THE VILLAS AT ALEXANDER PLACE
5516 BALLANTYNE COMMONS PARKWAY
CHARLOTTE, NORTH CAROLINA

Project
Sheet Title

Project Number
2080327
Sheet
2
Of
16

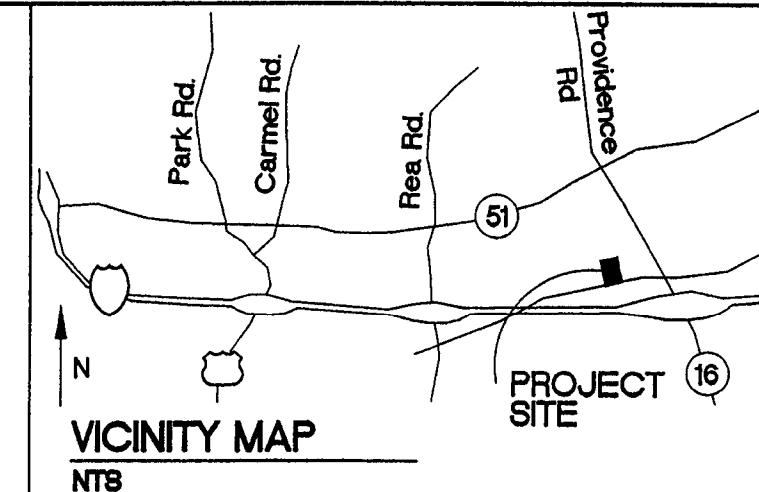
THE LIGHT POLES SHOWN ON THE PLANS WILL NOT BE REVIEWED AND APPROVED THROUGH THIS PROCESS.

THE INTERSECTION SIGHT DISTANCE LINE FOR PROPOSED CALDWELL PLACE LANE GOES OUTSIDE OF THE RIGHT-OF-WAY LINE AND A SIGHT DISTANCE EASEMENT WILL NEED TO BE RECORDED. ANY ITEMS IN THE SIGHT DISTANCE TRIANGLE WILL NEED TO BE IDENTIFIED AND ANY TREES WILL NEED TO BE LIMBED UP 6 FEET.

SITE IS ADJACENT TO CITY ENGINEERING PROJECT #512-08-007 - SIDEWALK PROJECT ON BALLANTYNE COMMONS PARKWAY. PROJECT MANAGER IS SHARON BUCHANAN
